Access Compliance Report

Public Rights-of-Way

(Curb Ramps)

Intersection ID: 20933	Main Street: OLD_FARM_RD	Cross Street: PROVIDENCE_RD	Location: W
ADA ID: E0551C7B43B0	Ramp Type: PerpDiag	Initial Pass/Fail: Fail	Overall Compliance: No
Codes/Mitigation Info/Possible Solution		Field Measurements/Component Compliance	
Severity Score: 37.5

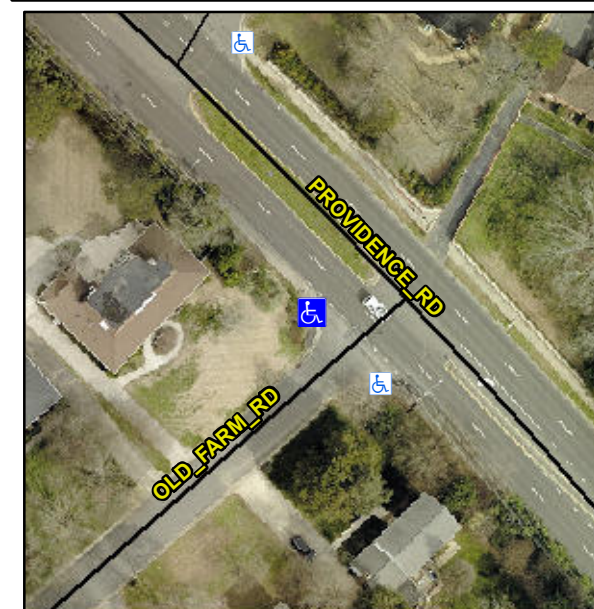
Not Found, R304.2.2, R304.5.3

Compliance	Description	Data	Compliance	Description	Data
N/A	Ramp Length (in)	56.0	No	Ramp Slope (%)	12.0
Yes	Ramp Width (in)	48.0	No	Ramp XSlope (%)	6.9
N/A	Flare Type LT	N/A	N/A	Flare Type RT	N/A
N/A	Flare Slope LT (%)	N/A	N/A	Flare Slope RT (%)	N/A
N/A	Flare Traversable LT?	N/A	N/A	Flare Traversable RT?	N/A
N/A	Landing Length (in)	N/A	N/A	DWS Provided?	N/A
N/A	Landing Width (in)	N/A	N/A	DWS Contrast?	N/A
N/A	Landing Slope (%)	N/A	N/A	DWS Length (in)	N/A
N/A	Landing X Slope (%)	N/A	N/A	DWS Full Width?	N/A
N/A	Landing Curb? (Y/N)	N/A	N/A	DWS Offset (in)	N/A
N/A	Shared Landing?	N/A			
N/A	Gutter Ponding?	N/A	N/A	Gutter Slope (%)	N/A
N/A	Gutter Lip Ht (in)	N/A	N/A	Gutter X Slope (%)	N/A
N/A	Painted X Walk1?	No	N/A	Painted X Walk2?	No
	X Walk 1 Direction	To SE		X Walk 2 Direction	To NE
N/A	X Walk 1 Width (in)	N/A	N/A	X Walk 2 Width (in)	N/A
	X Walk 1 Slope (%)	4.2		X Walk 2 Slope (%)	0.3
	X Walk 1 X Slope (%)	0.9		X Walk 2 X Slope (%)	3.3

Remove & Replace Curb Ramp With Two New Directional Ramps or Equivalent.
